**Fort St. Vrain Nuclear Station
Decommissioning Project**

**FSV FINAL SURVEY EXPOSURE
RATE MEASUREMENTS**

May 17, 1996

RESPONSE TO COMMENTS PROVIDED 3/19/96

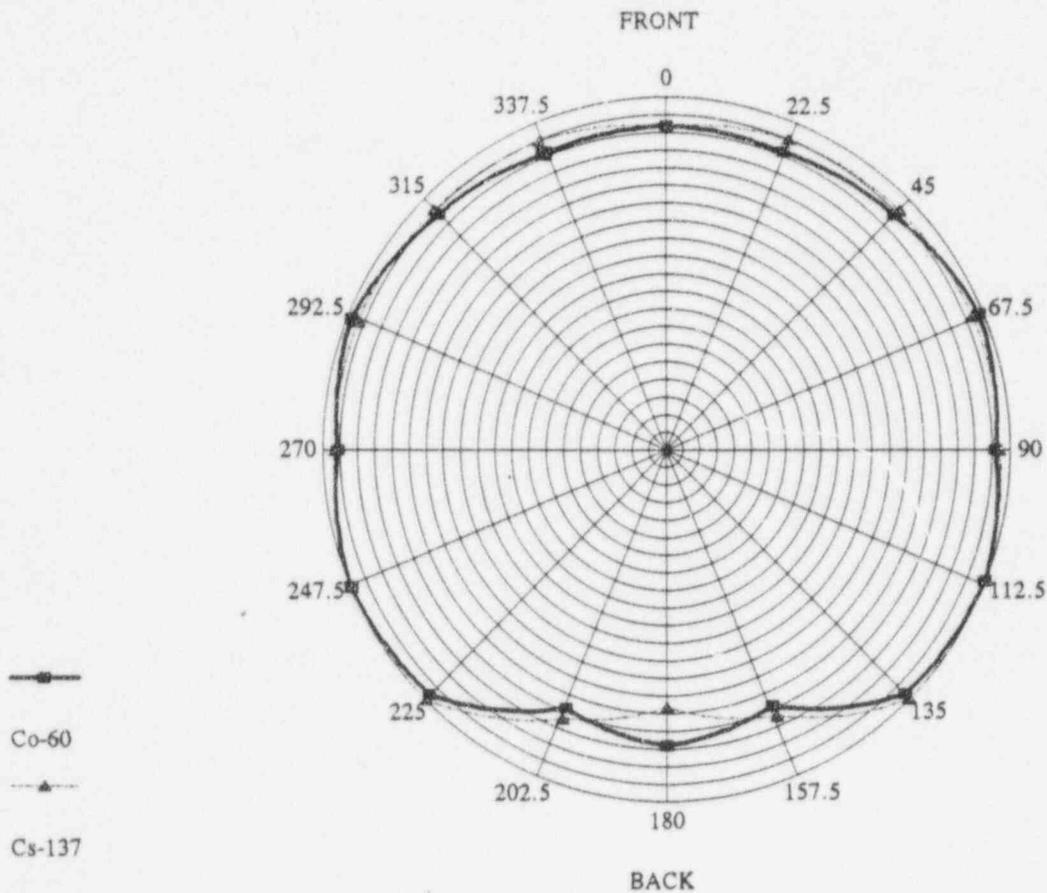
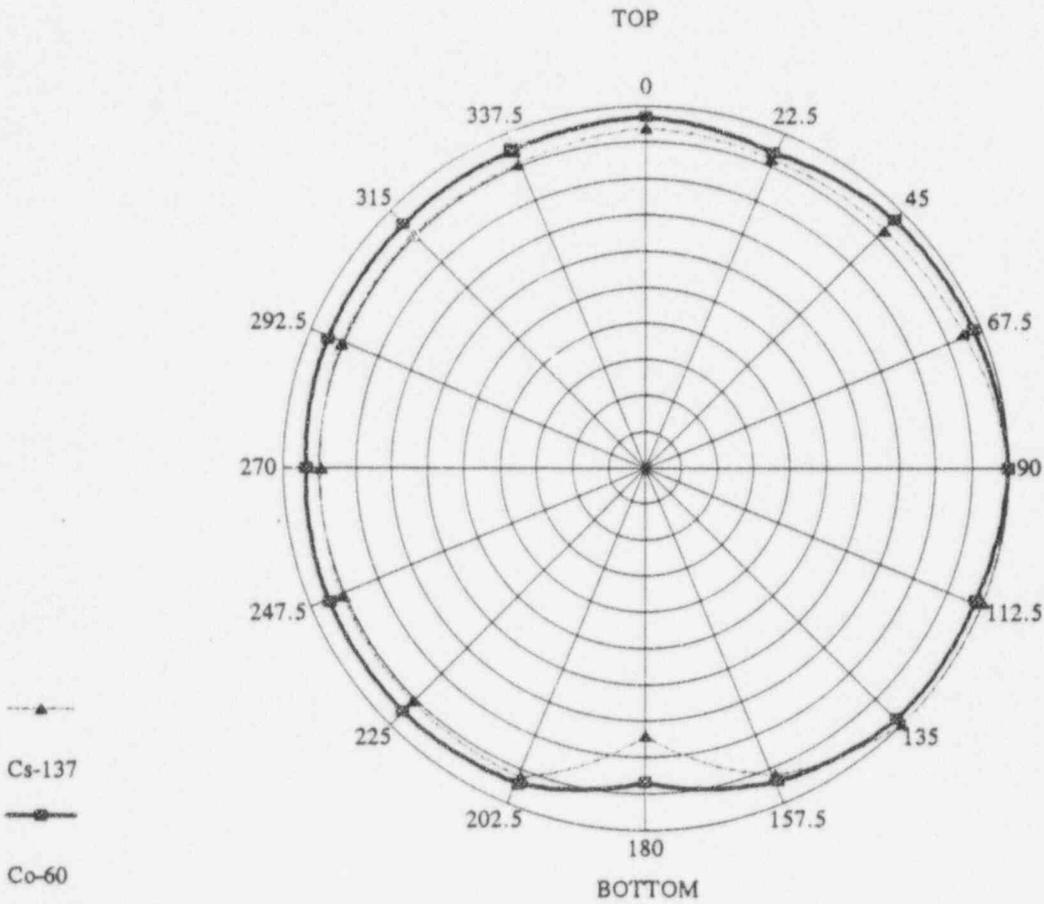
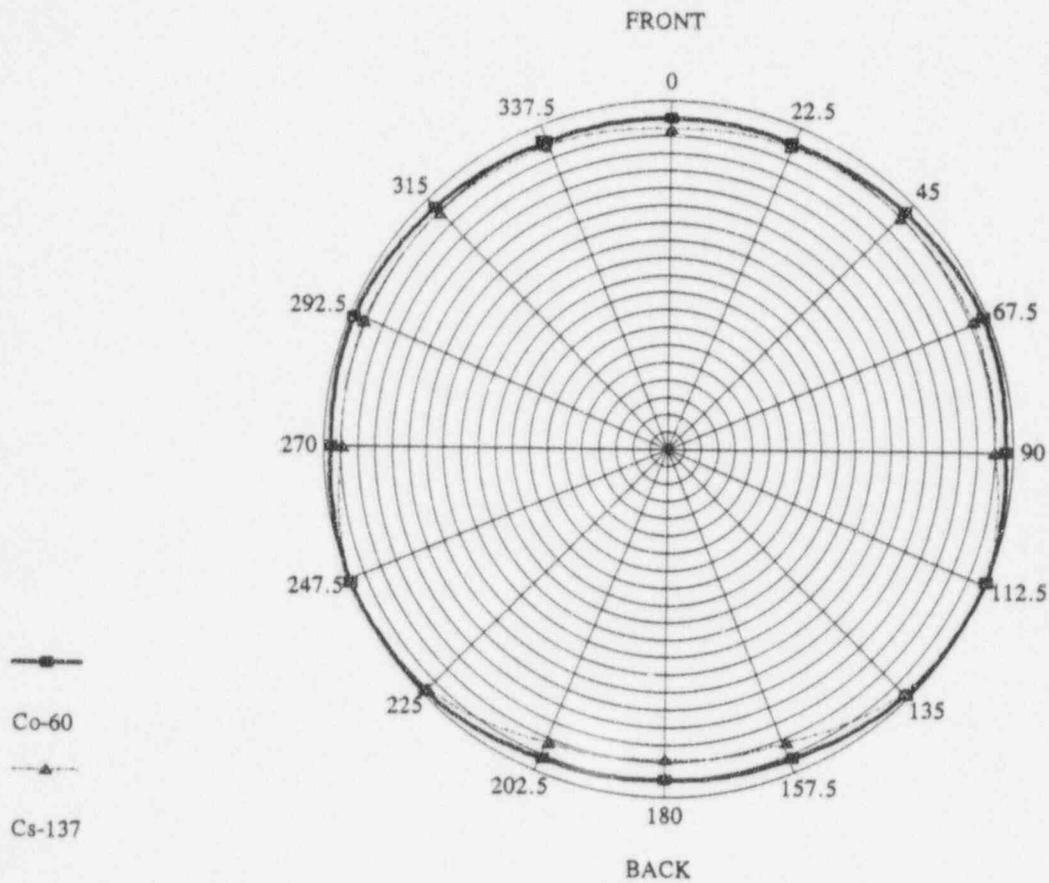
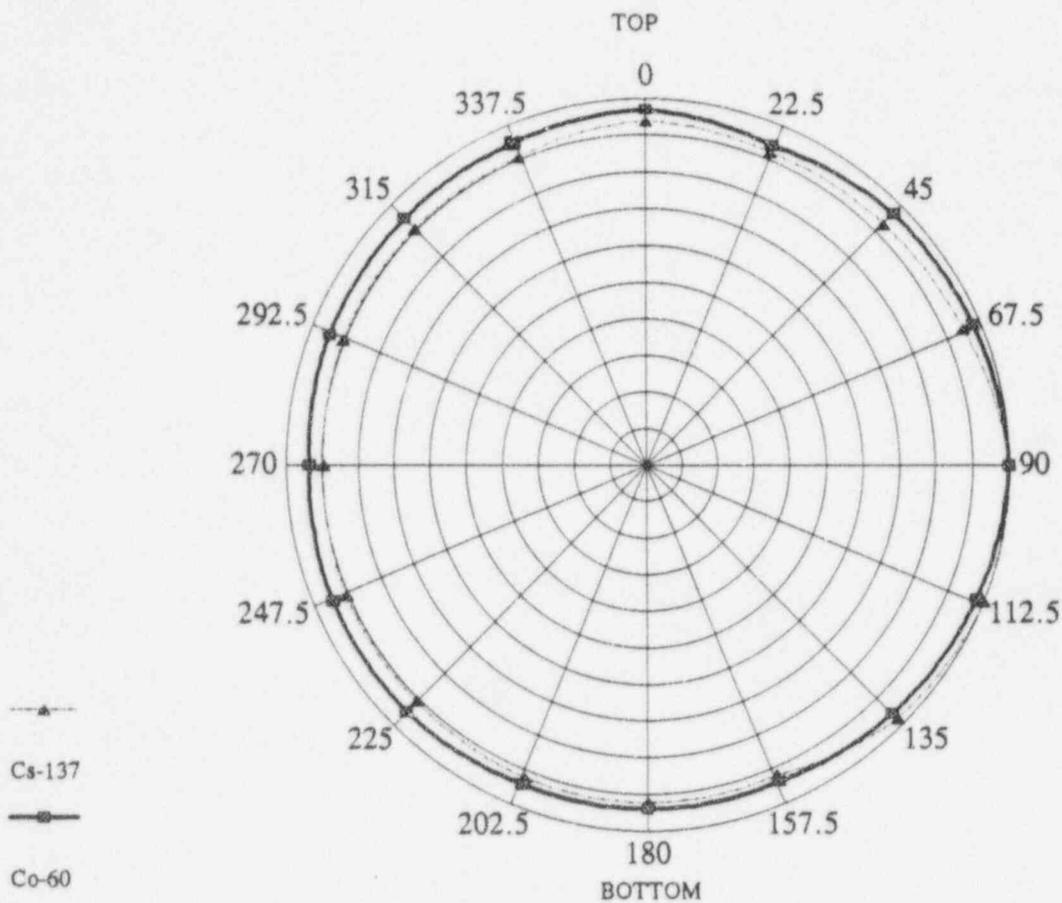
4. **Compare MICROSPEC results with the Pressurized Ion Chamber (PIC). What corrections will be applied to the results obtained with the MICROSPEC to compensate for response differences (MICROSPEC vs. PIC)?**

Several evaluations have been performed using the MICROSPEC and the PIC in an attempt to better understand the response of the two instruments. These evaluations were also designed to determine the need to correct the results of the MICROSPEC to provide PIC equivalent exposure rate and the result of this correction.

- The first of these evaluations involved determining the response of both

instruments at various angles of incidence, beginning at 0 degrees (directly in front of the MICROSPEC NaI detector and top center of the PIC) and continuing around the instrument at 22.5 degree increments to a maximum of 337.5 degrees. This was performed initially with a Co-60 source and then repeated with Cs-137. To ensure consistency in comparison of the response of the two instruments, the source was placed at a distance measured from the detector centerline for all measurements. When measuring the source distance for the PIC, the detector centerline was assumed to be the center of the 1 ft³ outer box.

Measurements were performed at a source distance of 9" from the detector centerline for both instruments and both sources (Figures 3 and 4), then repeated at a distance of 27" (Figures 5 and 6). At the 9" measurement distance, the MICROSPEC response was uniform to an angle of 112.5 degrees, increasing to 135 degrees as the distance was increased to 27". As expected the response decreased as the angle approached 180 degrees. However, when the source distance was increased, the response improved at these angles with a maximum 9% under response for Co-60 and 18% under response for Cs-137 at 180 degrees. The PIC displayed a similar response, uniform to 157.5 degrees, with a maximum under response at 180 degrees. This response also improved as the source distance was increased, with a maximum under response of 7% for Co-60 and 8% for Cs-137 at 180 degrees. It is important to note that 180 degrees on the PIC was found at the location where the steel plate is attached to the box for securing the detector tripod. At most measurement locations this is the angle of interest (source term contributing to exposure rate from underneath the detector). Graphs of the angular response for the PIC and MICROSPEC at both measurement distances are attached.
